From: Pierre du Toit
Sent: Thursday, October 12, 2023 4:53 PM
To: James, Jonathan <Jonathan.James@wiltshire.gov.uk>
Subject: Land South of Back Lane, Ramsbury - PL/2023/07437

Proposed Dwelling, Back Lane, Ramsbury

Planning Comments Response Schedule

PL/2023/07437

SITE SECTION AA - AA

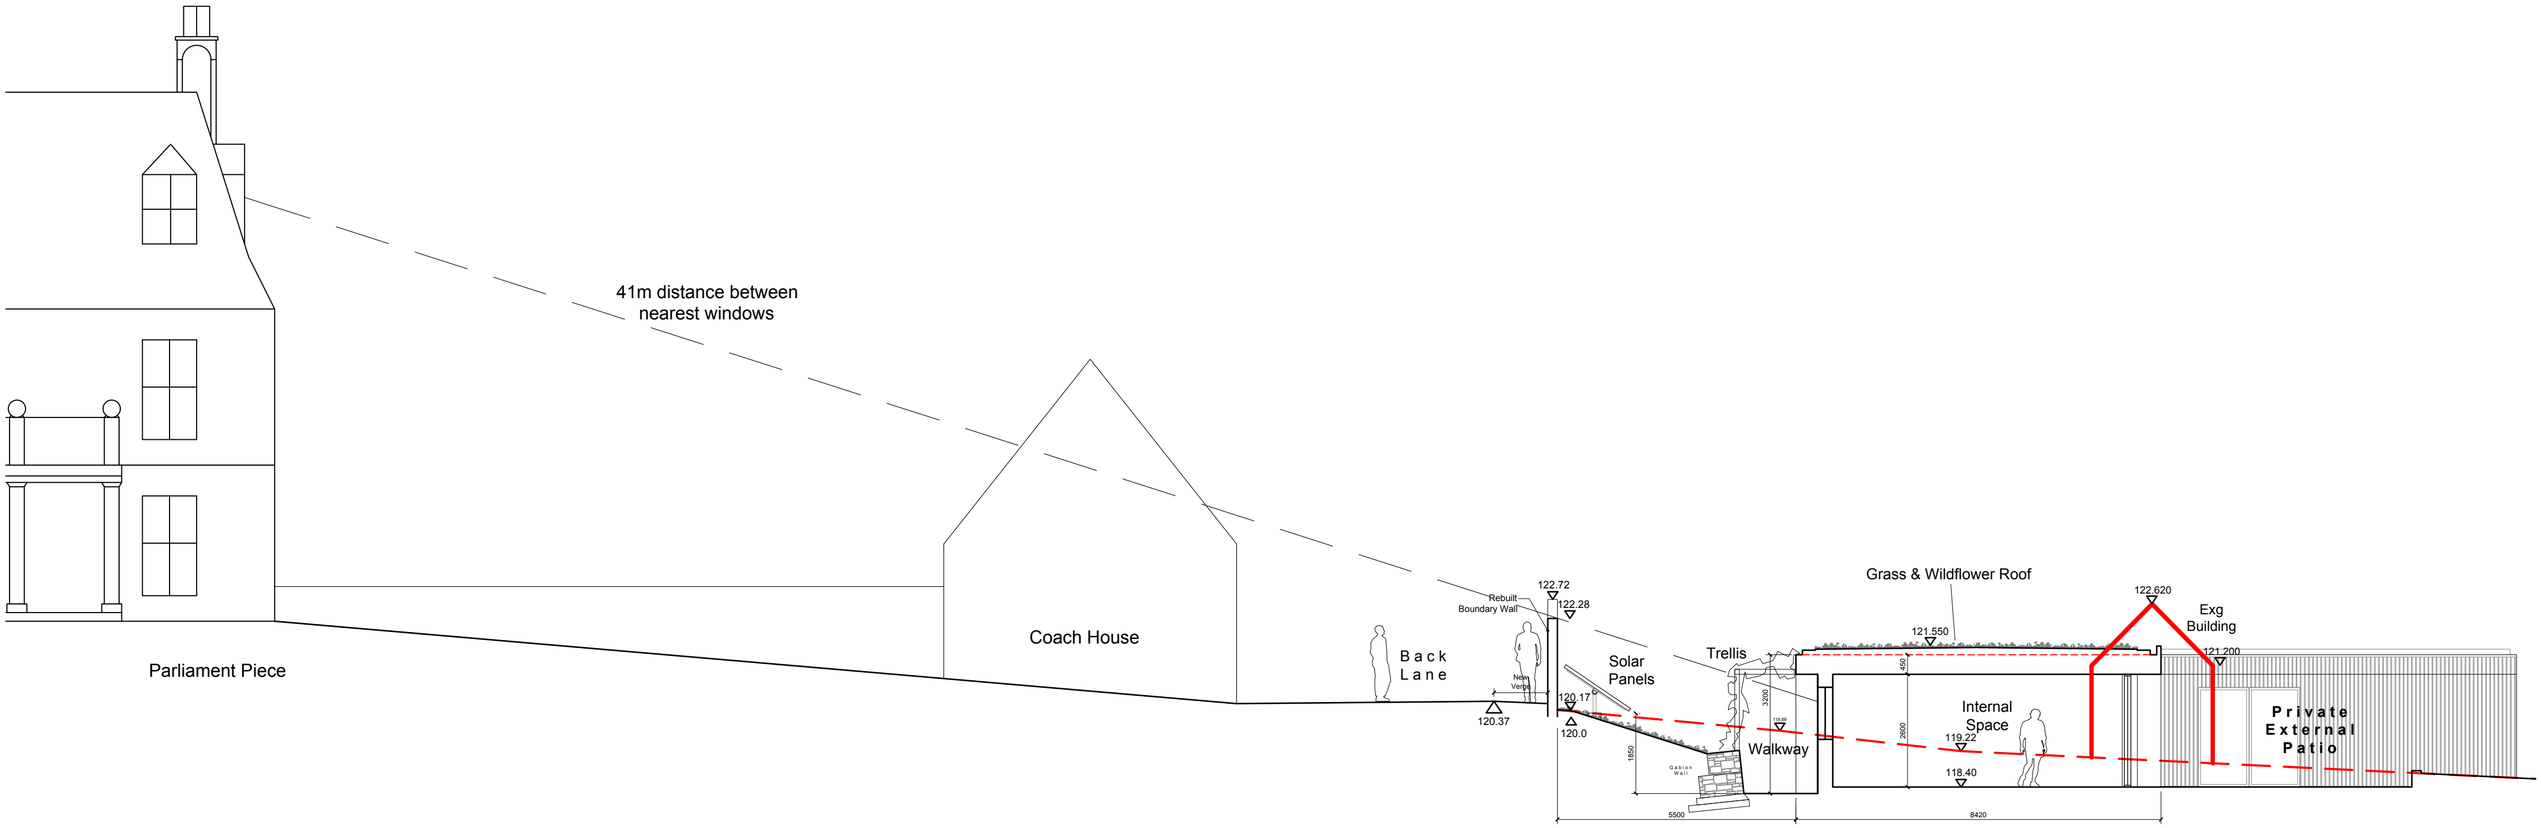
3		It would also appear that the roof of the proposed dwelling is higher than that of the consented scheme. Unfortunately the submitted application does not give dimensions, so we have scaled this from the drawings. Our measurements (see below) suggest a 55cm increase in roof height.D17:D19	* Drawing 30(A)-Clarifying Site Section AA-AA, is provided to clarify levels, positions and sightlines. * All Levels are related to Ordnance. Finished Floor Level is proposed at 118.40 and the top of the Green Roof is 121.550. * Top of boundary wall levels vary between 122.72 near the western end and 122.28 on the east side. The roof level is therefore between 730mm and 1170mm **below** the top of the boundary walls. * Due to the proposed roof being a minimum of 700mm below the Back Lane walls, and the fact that vantage points into the site can only be from elevated positions, one will always be looking DOWN into the site. Therefore the house cannot be seen above boundary walls on the far sides and therefore it cannot obscure or interrupt views ACROSS the site.

5		We note that a topographical survey has been submitted as part of the application. For example, it appears to show a current ground level of 119.22 and a proposed floor level of 118.40, i.e. a level difference 82cm below current ground floor level. Cross Section A-A does not provide a proposed roof height, which we consider to be a fundamental requirement before the application can be considered. We also do not know where cross section A-A is taken from as there is no plan showing its location. It may well be that at certain points the level difference may be greater or less 82cm, however it is impossible to tell from the submission as it stands. Likewise, the wall is shown at 122.28, however this may vary along Back Lane, offering more or less screening from the development. When we scale the planning application drawings against the consented drawings, it suggests: - the difference in height between the top of the existing boundary wall and the top of the main roof on the consented scheme is 175cm - the difference in height between the top of the existing boundary wall and the top of the main roof on the application is 120cm In addition to the cross section drawing, we therefore request details of the wall height, floor levels and proposed roof levels, relative to current ground levels on at least three points between the proposed dwelling and Parliament Piece and the Coach House. These drawings should be stand alone drawings, as opposed to figures within the DAS, so that they can be listed as approved drawings on the decision notice and enforced. Once the requested levels have been provided and assuming that they are acceptable, we request that a condition is imposed on any approval to specify and enforce the finished floor level, maximum height of the building and future maintenance of	* Drawing 30(A) Clarifying Site Section AA-AA is provided to clarify levels and sightlines. * Please also refer to the submitted Topographical Survey. * The previous approval had a condition that requested levels to be approved and condition discharged before commencement of works. We have provided levels on the submitted plans and now on the section and therefor hope the levels can be approved as part of the main approval and not conditioned. * Top of boundary wall levels vary between 122.72 near the western end and 122.28 on the east side. The roof level of the proposed is therefore between 730mm and 1170mm below the top of the boundary walls.

2. A cross section demonstrating the relationship between Parliament Piece and the proposed dwelling, in particular the relationship with the new north facing windows.	See Drawing 30(A) Clarifying Site Section that has been submitted with these responses

3. A topographical survey of the site as existing.	Already submitted
		4. Clarity over the proposed finished floor levels, maximum roof height and boundary wall height for at least three points between the proposed dwelling and Parliament Piece and the Coach House. A comparison between these figures and the consented scheme. We reserve the right to comment on the additional information required. Should the application be approved, we request that conditions are imposed to enforce the finished floor levels, maximum roof height and maintenance of the boundary wall height.	See Drawing 30(A) Clarifying Site Section that has been submitted with these responses
